# SOARCA Peer Review Comments

(Feb. 25, 2010)  
DSE

## Peer Review Comment Mtg. (3/25/2010)

Figure 12 Schematic of Modeling Detail for BWR GNF 10x10 Assembly.

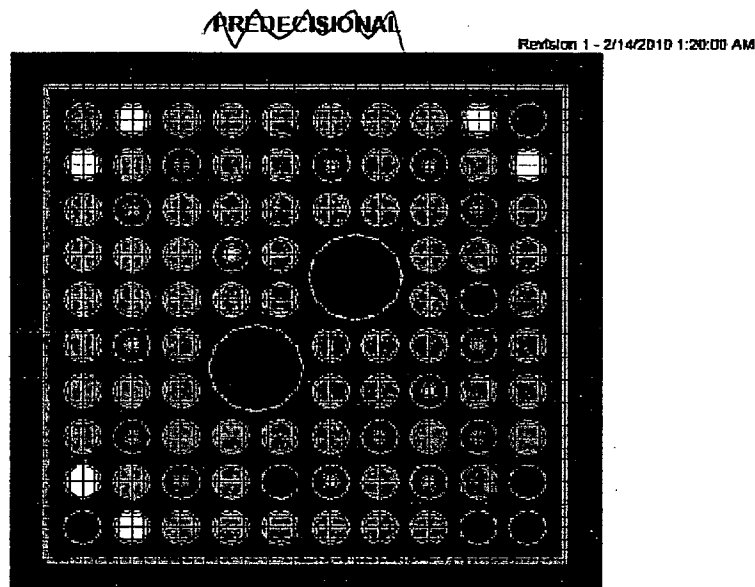
MWD/MTU?

Figure 2 Site Photograph.

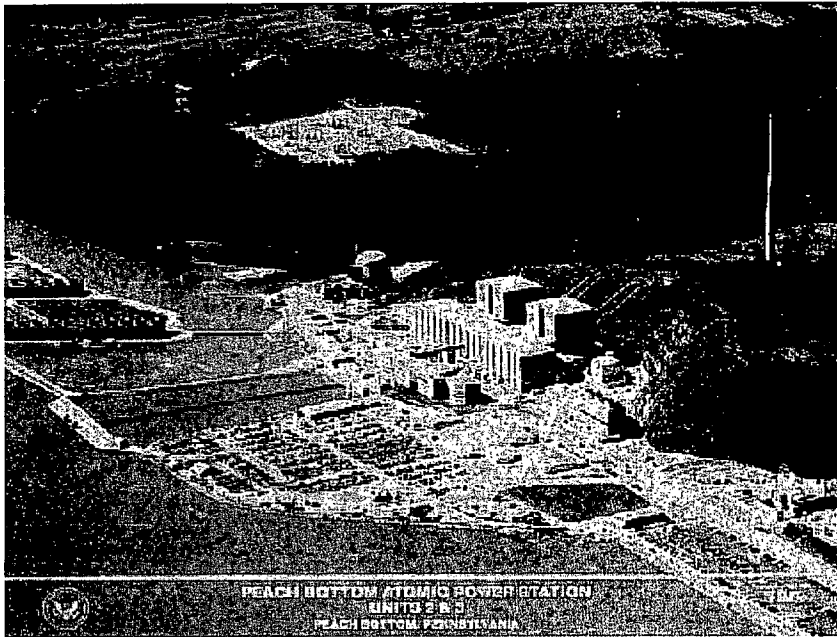
Figure 2 (site photo) does not show what it says it shows.
